# Modular Firmware V2.2.62\_230204 Release Note

## (2023-02-10)

Device Model	DS-KD8003-IME1、DS-KD8003-IME2
Firmware Version	V2.2.62_230204
iVMS-4200 Version	Latest version

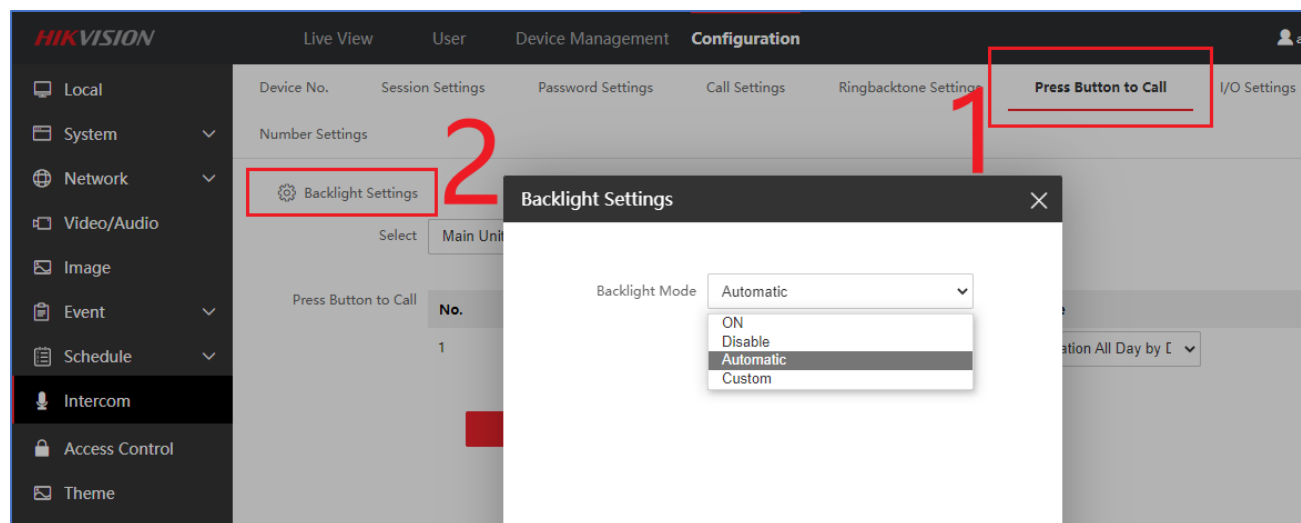
1. Add sub module **backlight** control: 4 modes (close, open, auto and custom), support DS-KD-KK, DS-KD-KP modules

**Close:** always OFF

**Open:** always ON

**Auto:** ON and OFF according to the ambient light brightness

**Custom:** ON and OFF according to configured time schedule

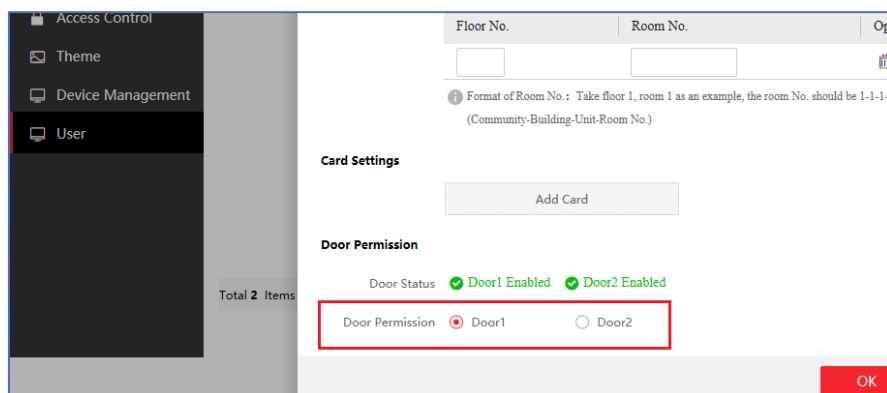
### 3. Support capture device image through ISAPI protocol.

*/ISAPI/Streaming/channels/1/picture?snapShotImageType=JPEG&videoResolutionWidth=1280&videoResolutionHeight=720&imageQuality=better*

**snapShotImageType:** picture format, only support JPEG now

**videoResolutionWidth:** videoResolutionHeight: picture resolution, if not use this parameter, by default it's 704\*576. Supported resolution: 1280\*720, 704\*576, 704\*480, 352\*288, 352\*240, 176\*144, 176\*120

**imageQuality:** support best, better, normal, general

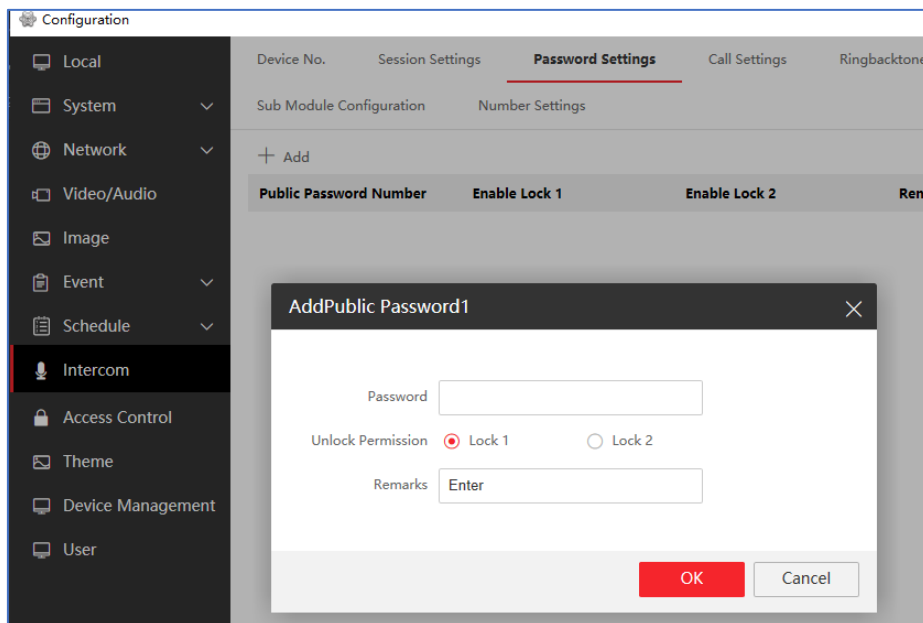
1. Support swipe card to open lock2: when adding new person, you can link to lock 1 or lock 2, and after swipe card, the related lock will be open.

**Note:** before the lock was linked to card module DIP switch, now we cancelled this logic so that we can open different lock with same card module.

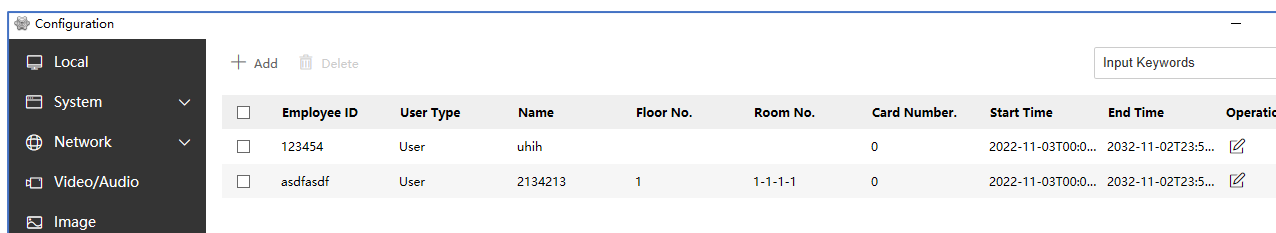
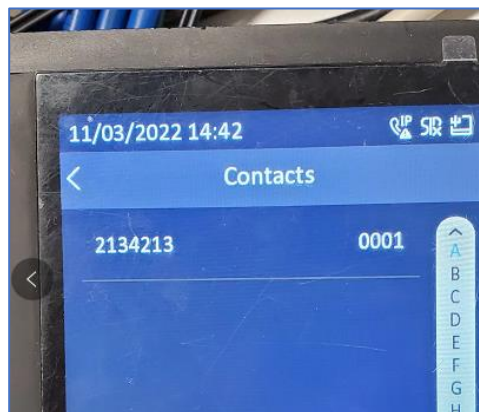
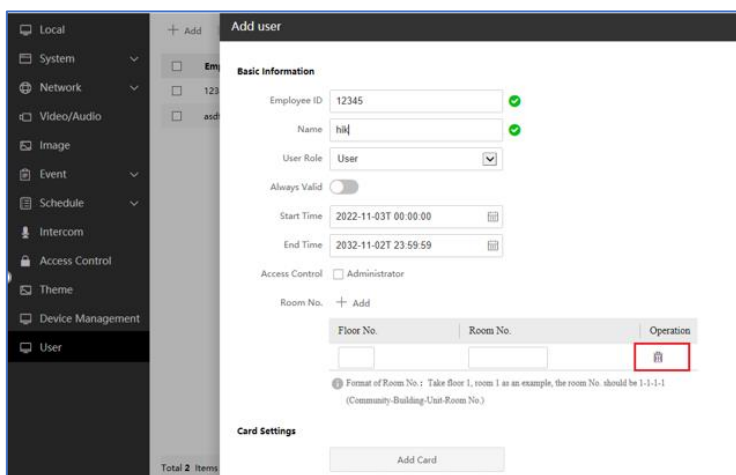
2. Support open door1 and door2 with different public password on same keypad DS-KD-KP or DS-KD-TD module.

- When open door2 with card or public password, but door2 is not enabled from main module KD8003, the device will prompt “Bi-Bi” sound and will not upload any event to iVMS or HikCentral (device will upload “invalid card” event in previous version firmware)
- Support not showing the person in DS-KD-DIS and KD-TDM module  
When adding person, if you don't input the room No., this person will not be displayed in KD-DIS or KD-TDM module

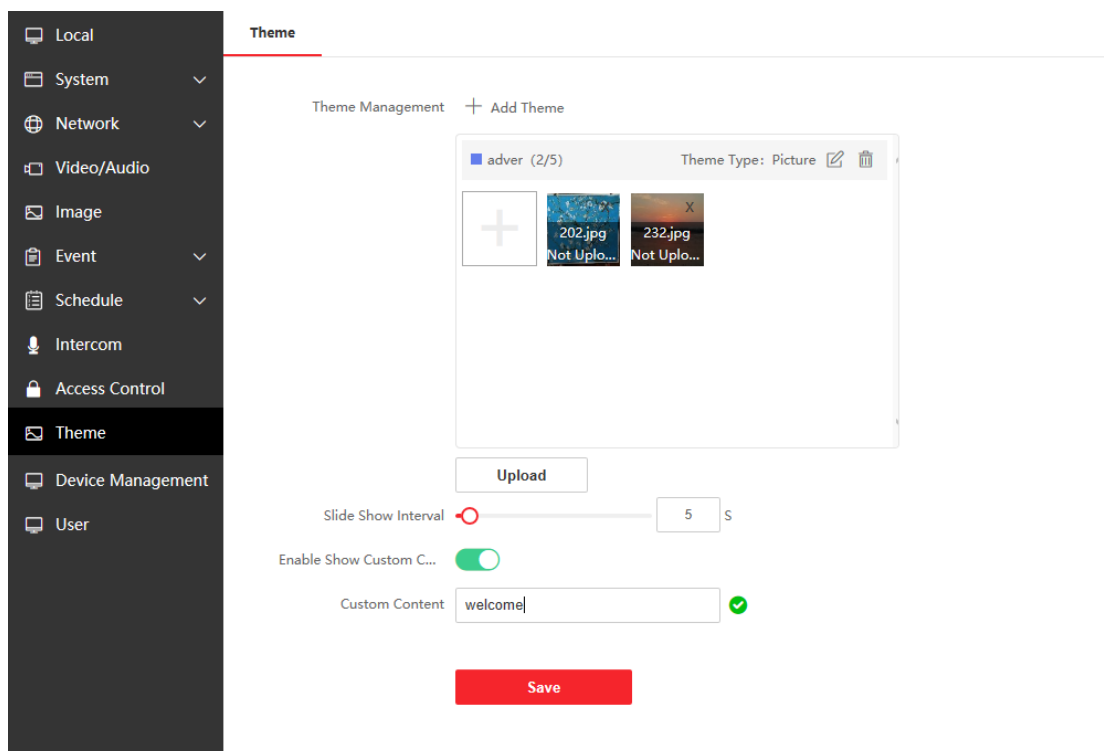
2. Supports multi-language switching without device rebooting.

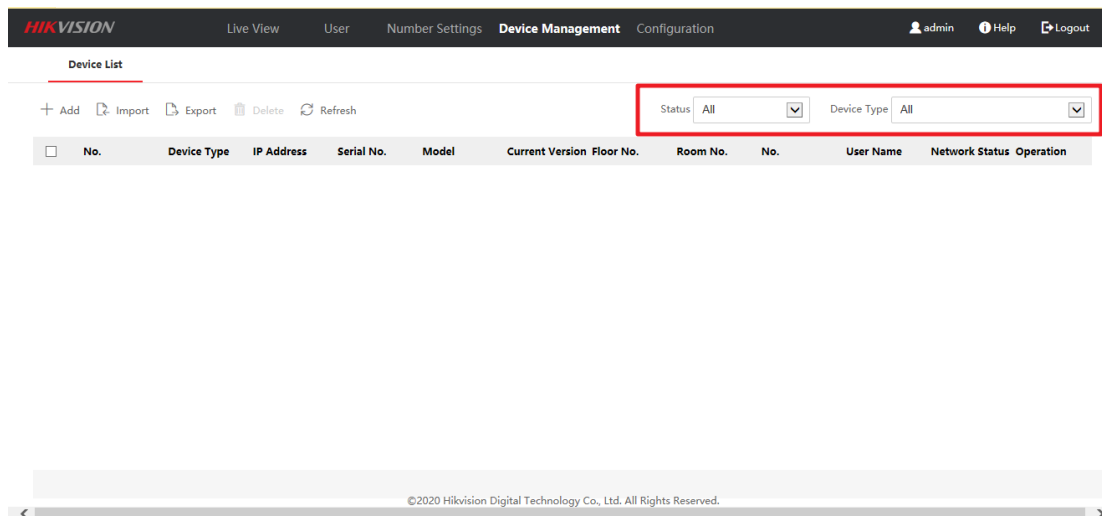
1. New refresh button is used to refresh the status of added devices

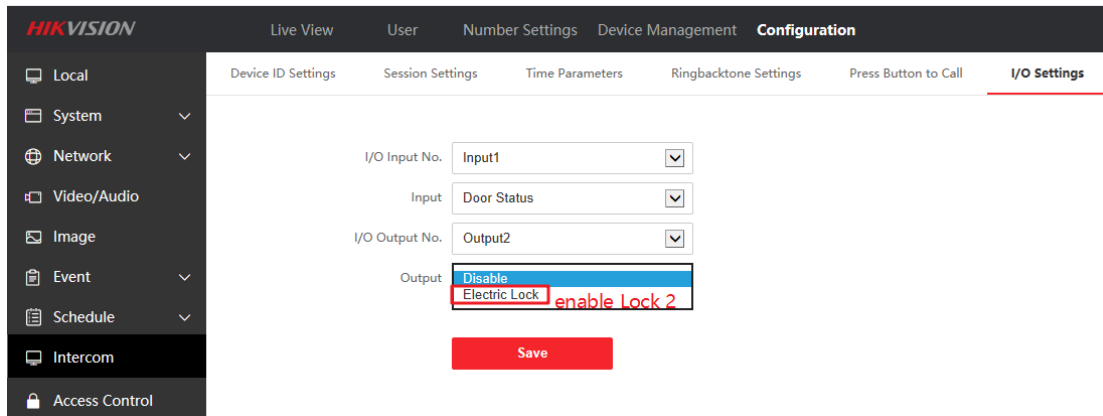
2. Added 'All' option, indoor station and sub-door station will be displayed together.
